## YEAR 5 OF 5 MONITORING REPORT - FINAL

**Five-Mile Branch Stream and Wetland Restoration, Iredell County  
NCDMS IMS ID# 92185**

**Responses to Comments**  
**Draft Year 5 Monitoring Plan**  
**for**  
**Five Mile Branch Stream and Wetland Restoration Site**  
**NCDMS IMS ID # 92185**  
**DEQ Contract# 6036**  
**Comments and Responses**

**PROJECT COMPONENTS MAP**  
FIVE MILE BRANCH RESTORATION SITE  
IREDELL COUNTY, NORTH CAROLINA

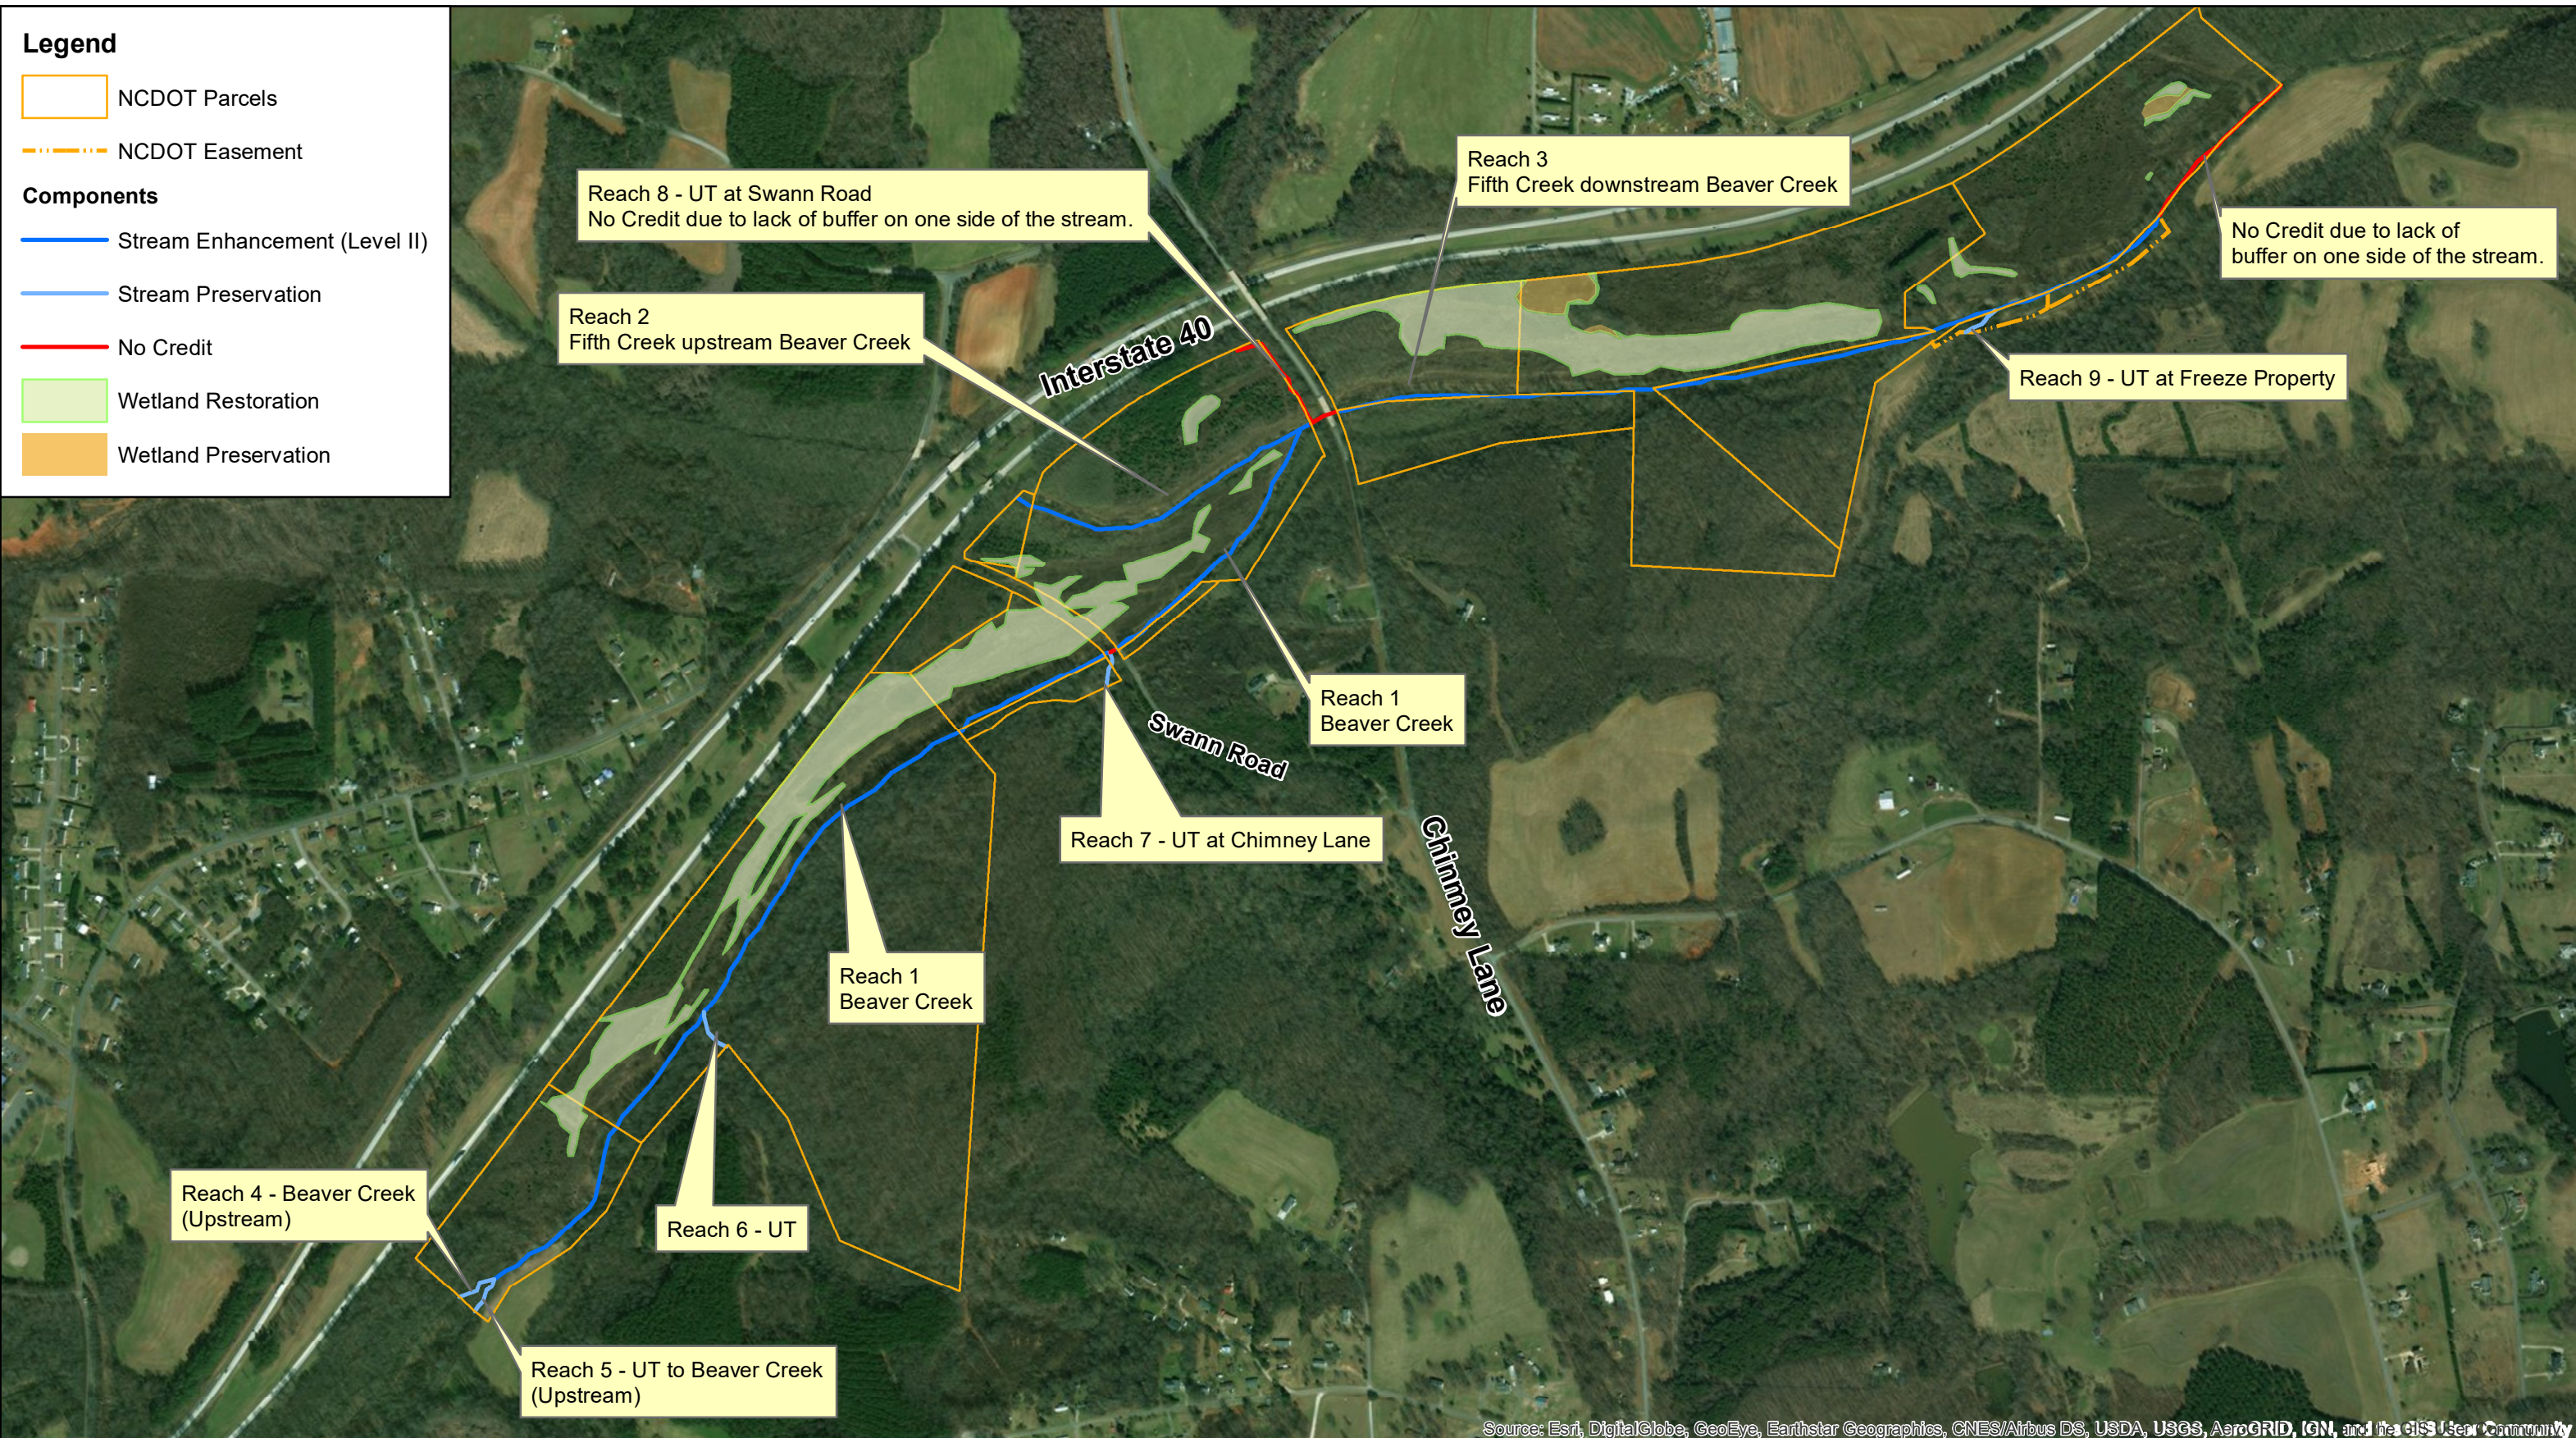
The area beneath the Chimney Lane bridge should be shown in red as "No Credit" in the Project Components Map.	
003	<b>General:</b> MY4 vegetation data was collected in September and October 2017. The MY5 vegetation data was collected in May 2017. Per the IRT, vegetation data should be collected at the end of the growing season for the applicable monitoring year. Please note that this could be an issue at project closeout with the IRT.	Noted.
004	<b>Section 1.3 – Vegetation:</b> In the report text, please note that invasive species treatments have been conducted site wide in 2015, 2016, and 2017. Please also note that invasive treatment will continue in 2018 until project closeout. Invasive treatment logs are included. Please include the treatment logs as an appendix in the FINAL MY5 report.	A paragraph was added discussing the invasive treatment and the treatment log were included in Appendix G.

009	<b>Table 2:</b> Please include the January 2016 supplemental planting (due to encroachment) and all invasive treatments to the table. Invasive treatment logs are included for reference. Please include the treatment logs as an appendix in the FINAL MY5 report.	Supplemental planting and invasive treatment dates were added to Table 2.
010	<b>Figure 1:</b> Please update NCDENR to NCDEQ in the figure text.	The text in Figure 1 was updated.
011	<b>Project Components Map:</b> Please remove the "Year 4 Wetland Delineation" label from the map legend. The project wetlands should be shown/ shaded as "Wetland Restoration" & "Wetland Preservation" with different colors to represent each approach on the map and in the legend. Additionally, the project streams should be shown/ colored as "Stream Enhancement (Level II)", "Stream Preservation" and "No Credit" with different colors to represent each approach on the map and in the	The Project Components Map was updated as commented.

legend. Please terminate stream shapes that are located outside of the project boundary to avoid confusion about project credits.	
012	<b>CCPV Sheets:</b> Please remove the "Year 4 Wetland Delineation" label from the map legend. The project wetlands should be shown/ shaded as "Wetland Restoration" & "Wetland Preservation" with different colors to represent each approach on the maps and in the legends.	The CCPV Sheets were updated.
013	<b>CCPV Sheets:</b> Please include the preservation streams on the CCPV sheets. Please also provide stream names and mitigation approaches (EII; Pres) on the CCPV sheets.	The CCPV Sheets were updated.
014	<b>CCPV Sheets:</b> Please update the aerial to the most recent available.	The CCPV Sheets were updated.
015	<b>CCPV Sheets:</b> If mapped invasive areas have been treated and are dead, please removed them from the CCPV sheets. If updated on the CCPV sheets, please make sure to update Table 6 as well.	The CCPV Sheets were updated.
